**ORAU COMMENTS/RECOMMENDATIONS
PRELIMINARY RESULTS AND RECOMMENDATIONS OF THE
INDEPENDENT ASSESSMENT OF PARCEL EVALUATION FINDINGS REPORT
FORMER HUNTERS POINT NAVAL SHIPYARD,
SAN FRANCISCO, CALIFORNIA**

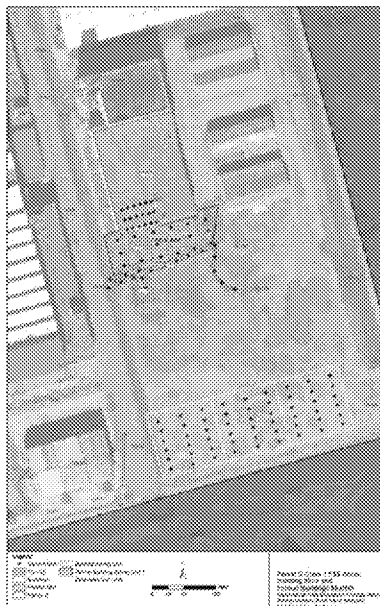
- A. Documentation provided to ORAU, including the various parcel radiological data evaluation findings reports and the *Basewide Radiological Removal Action Memorandum* (BRRAM), does not imply or otherwise state whether the DCGL/risk/dose compliance criteria include application of the unity rule. Rather, the text provides general statements, such as the following in Sections V.A., V.A.1, and V.A.5 of the BRRAM:

- a) “MARSSIM guidance is being used to apply the cleanup goals.”
 - b) “Soil confirmation sampling and analyses; comparison of results against cleanup goals listed in Table 1 using MARSSIM methodology”

- c) “Application of soils, debris, and surface cleanup goals to sites: MARSSIM guidance”
 - i. Per Appendix A of the BRRAM, “The Navy would apply this requirement...”—in reference to the Radiological Criteria for Unrestricted Use at Closing NRC Licensed Facilities—“...with the exception that 15 mrem/yr TEDE is substituted for 25 mrem, as ALARA.” As the Table 1 residual doses range from 0.05263 to 25 mrem/yr for the respective release criteria, ORAU assumed at the time of this review that the unity rule could be required to demonstrate compliance. Since that time and participation in the January 17 and 18 technical team, it is ORAU’s understanding that the criteria apply independently. Whether the release criteria apply independently, but more importantly if the unity rule is required, the Navy should consider increasing m (background reference area) and n (survey unit) sample populations from 18 to minimize Type II error probabilities. Otherwise, consider assessing available sample data to estimate the mean and standard deviation (in terms of unity if the unity rule will be applied, or if not, for each primary radionuclides of concern (ROCs) to estimate the worst case relative shift. Next, evaluate the relative shift and corresponding sample size with the proposed n and m of 18. Prepare a prospective power curve to assess probability of Type II error.

- ii. Additionally, the Class 3 plan specifies a 99% confidence that the concentrations of ROCs do not pose a risk. The plan should specify the confidence level (and

associated Type I error) for the Class 1 investigation. Will the planned confidence be the default of 95% (Type I decision error limit of 0.05) or is the intent to also impose 99% confidence (Type I decision error limit of 0.01) in the release decision for Class 1 areas? If the latter, the selected Type I error may also impact the necessary sample size. For example, the proposed sample populations of 18, assuming the default regulator acceptable error 0.05 (95% confidence level) and Type II error of 0.05 corresponds to a relative shift of 1.5. However, if the Type I error is changed to 0.01 (99% confidence) and all other variables are held constant, the population for n and m increases to 25 to achieve the desired confidence level.

- B. Although the rectangular sample pattern is acceptable for this type of planned investigation, the recommendation is that a triangular pattern be substituted to increase probability of identifying residual areas of elevated radionuclide of concern (ROC) concentrations, in particular for survey units where scanning may provide limited information due to backfilling or otherwise assessing subsurface soils.

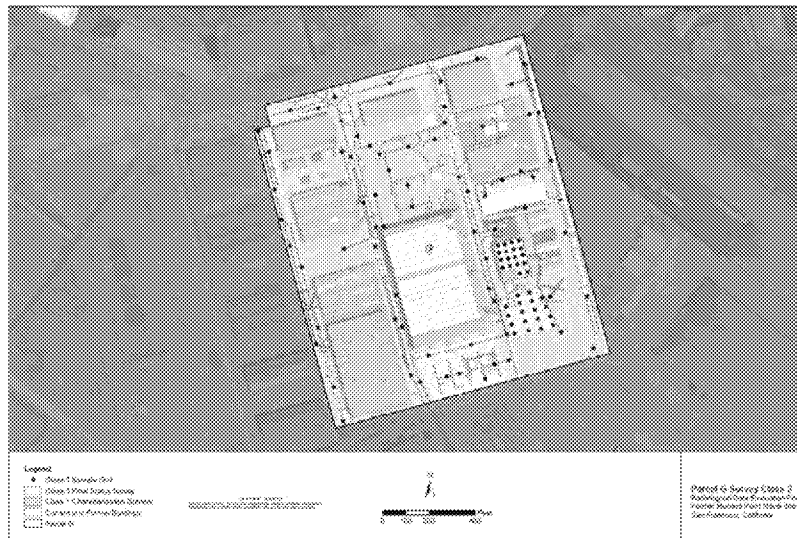
- A. Refer to comment/recommendations A.i, A.ii, and B above for Proposed Approach Item 1.
